STATE OF MICHIGAN
DEPARTMENT OF TRANSPORTATION
LANSING

April 25, 2022

Subject: Standard Plans R-4-E, R-15-G, R-20X-E, R-27-F, R-28-J, R-33-G, R-40-I, R-102-C,
B-22-E, B-23-F, B-50-A, & B-101-G

The Michigan Department of Transportation has revised the subject standard as follows:

4-7-2022 F.H.W.A. APPROVAL	7-27-2021 PLAN DATE	R-4-E	SHEET 4 OF 4
-------------------------------	------------------------	--------------	-----------------

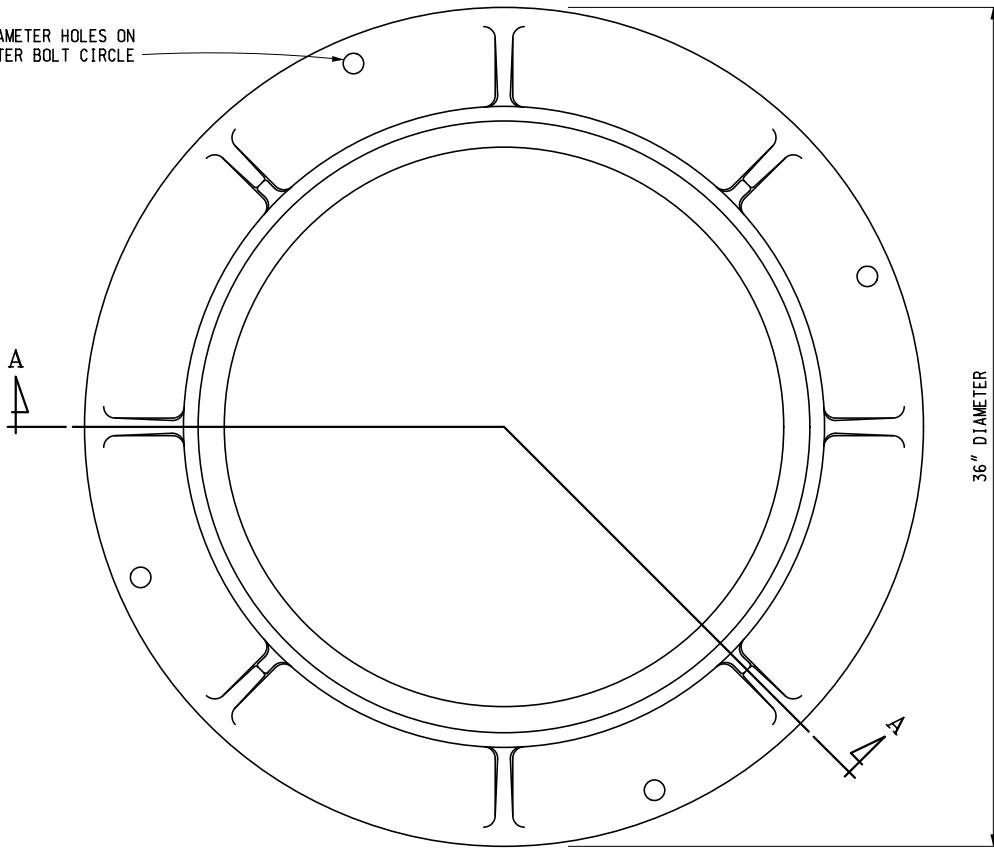
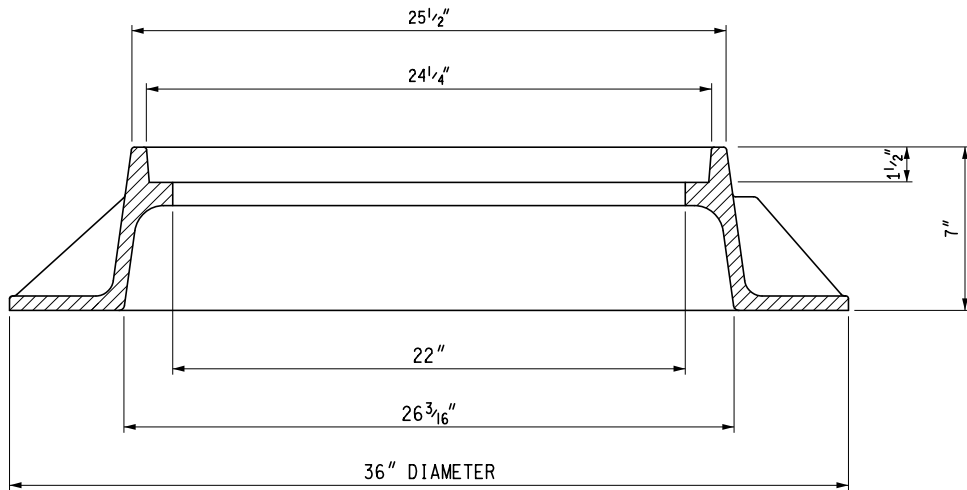
| Standard Plan R-4-E | Eliminated an outdated reference to Grade P2 concrete in favor of the current Standard Specifications for Construction. |

LIFT HOLE DETAIL

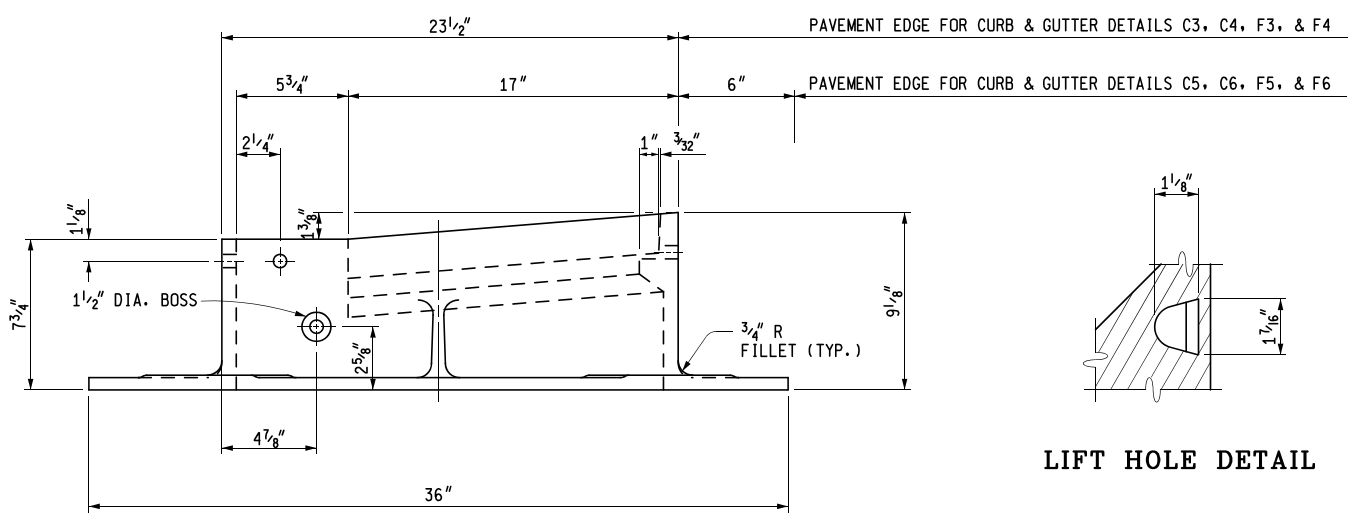
| Standard Plan R-15-G | Added an optional lift hole (and detail) to the frame. |

COVER RX
(FREEWAYS ONLY)

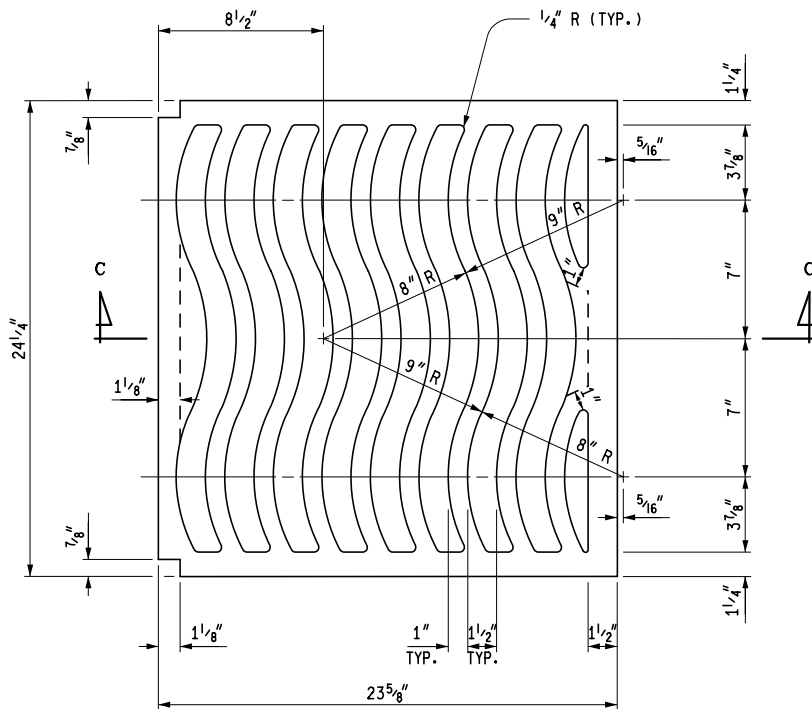
| Standard Plan R-20X-E | Eliminated “For use on manholes” in the title block. |

BRIDGE APPROACH CURB & GUTTER, DETAIL 4A
 (USING EXISTING CATCH BASIN)

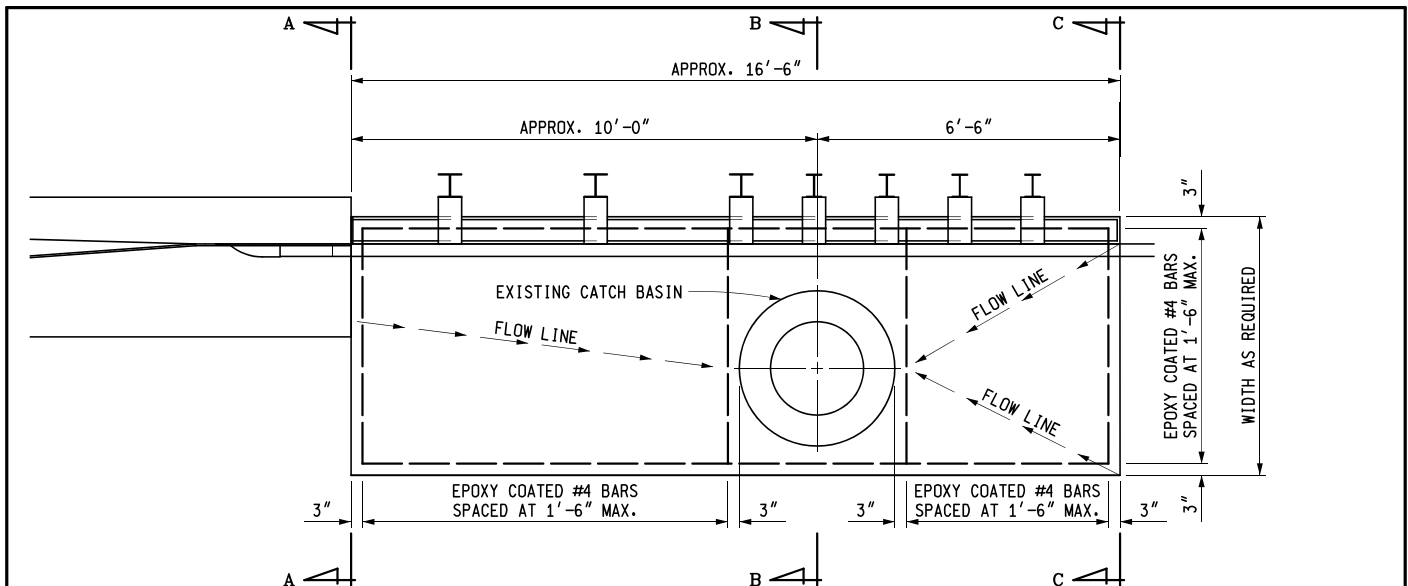
| Standard Plan R-27-F | Eliminated Detail 4 (with the 12” curb height) since this height is not allowed with the new MASH compliant anchorages. Revised Detail 4A (with the 4” curb height) for use on both approach and departing ends. Also, revised the shape of the barrier (end of bridge railing) and added text indicating use with the Detail “M” anchorages and the required number of drainage structures based on a hydrological analysis of the area and size of bridge deck. |

4-7-2022 F.H.W.A. APPROVAL	5-8-2020 PLAN DATE	R-28-J	SHEET 6 OF 7
-------------------------------	-----------------------	--------	-----------------

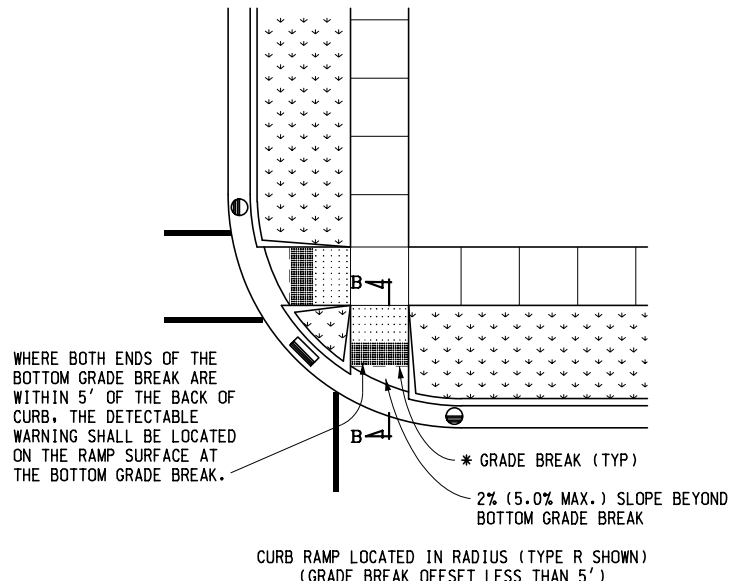
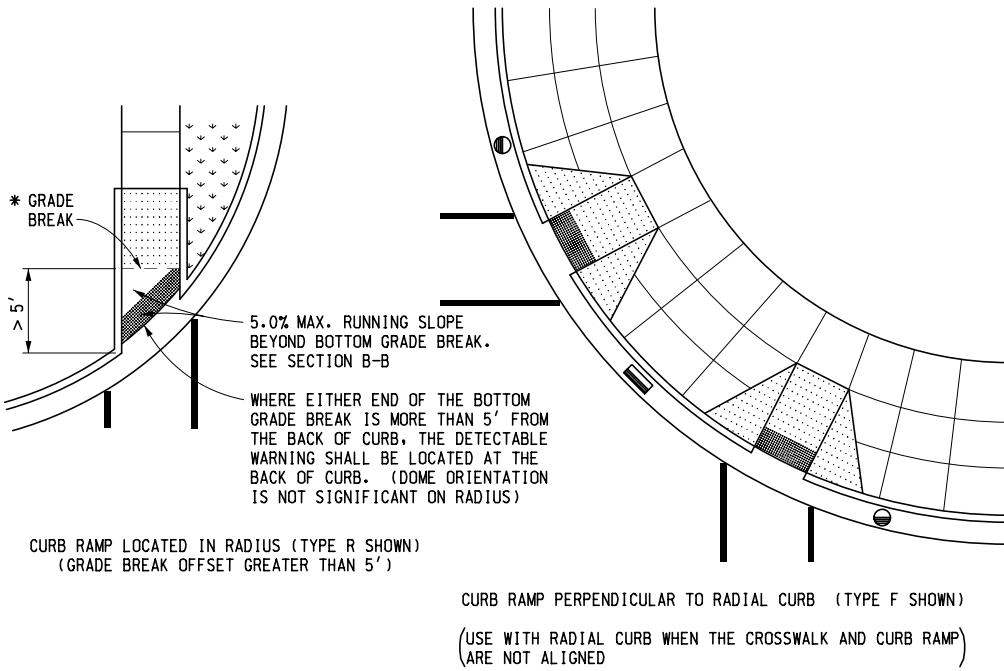
| Standard Plan R-28-J | “Turning spaces” were renamed “landings” and Sidewalk Ramps” were renamed “Curb Ramps”. On sheet two (and illustrated on sheet 6), added reinforcing bars in the curb ramp opening and a tie bar from the pavement to the curb ramp opening with a note stating reinforcement as in adjacent curb and gutter, see Standard Plan R-30-series. Modified the detail at the bottom of sheet two (section through curb ramp opening) to emphasize the slopes required in the curb ramp opening area. Maximum vertical dimensions from the curb invert to the two edges of the curb and gutter opening (labeled “A” & “B”) were provided (Table) for various curb types. On sheets two and six, the term “curb cut” or “curb & gutter” were revised to “curb ramp opening” and “ramp” was changed to “ramp run”. A landing was eliminated in the Ramp Type C sketch on page three. Eliminated notes in the note section on providing turning spaces where pedestrian turning movements are required and transitioning the gutter pan cross section. Clarified a note in the note section regarding the running slope and the 15’ maximum length of a ramp. Eliminated a portion of the |

**BRIDGE RAILING,
CONCRETE BLOCK RETROFIT
(CURB HEIGHT ≥ 10")**

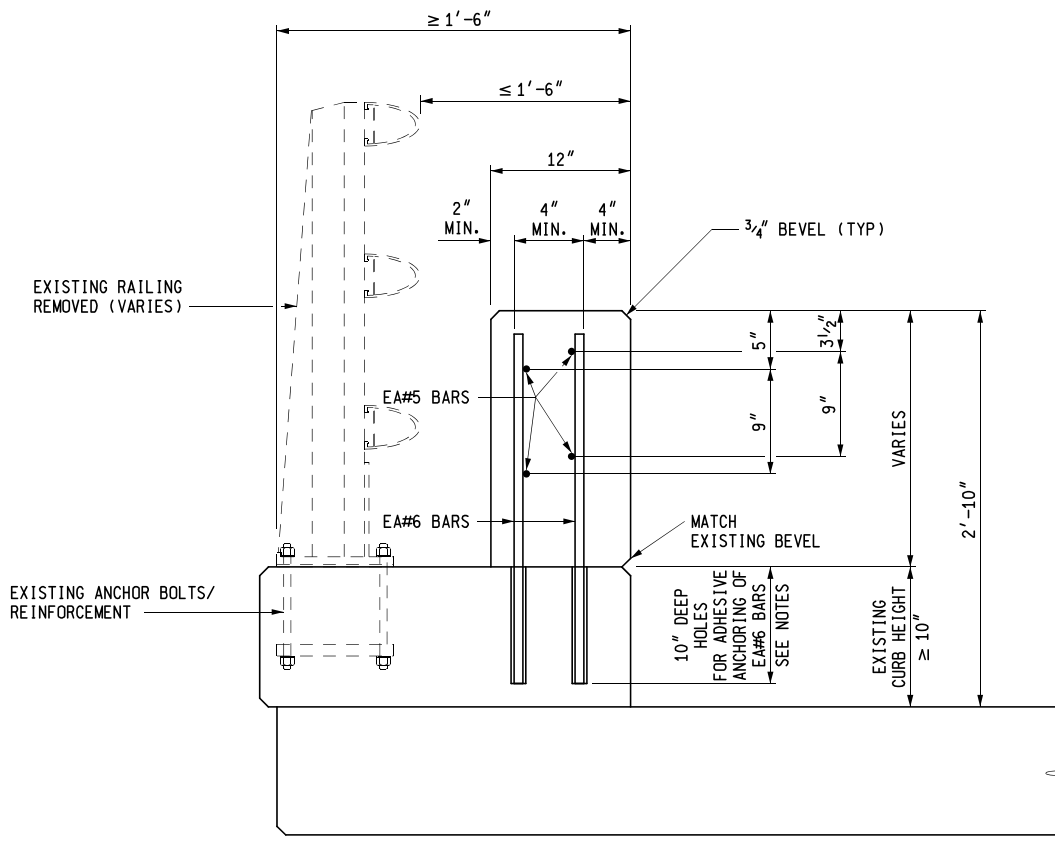
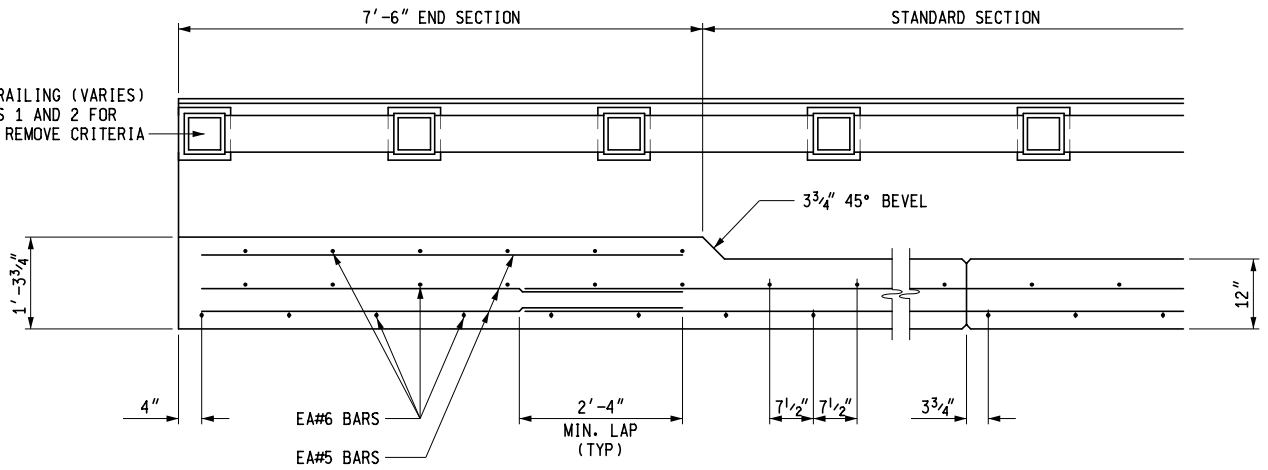
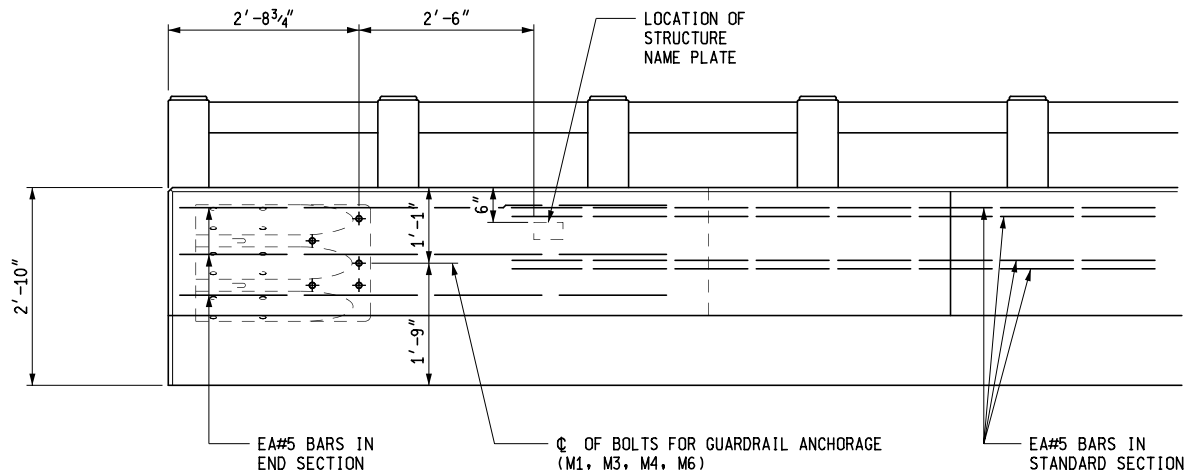
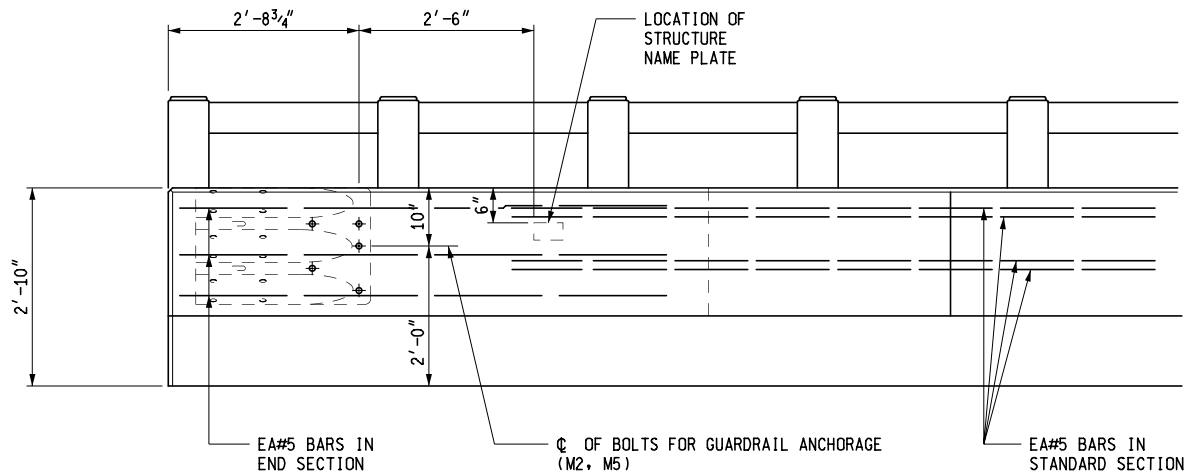
Standard Plan B-50-A	New bridge railing to be used with >10” brush block or sidewalk. The concrete block is located at the face of the brush block or sidewalk and protects the existing railing, or the existing railing is removed.
Standard Plan B-101-G	Updated notes, as most of the information is now covered in the 2020 Standard Specifications. Updated note on sheet 2, Section B-B, for steel beam connection regarding installation (snug tightening) of brackets. Updated allowable concrete beam insert types and material requirements.
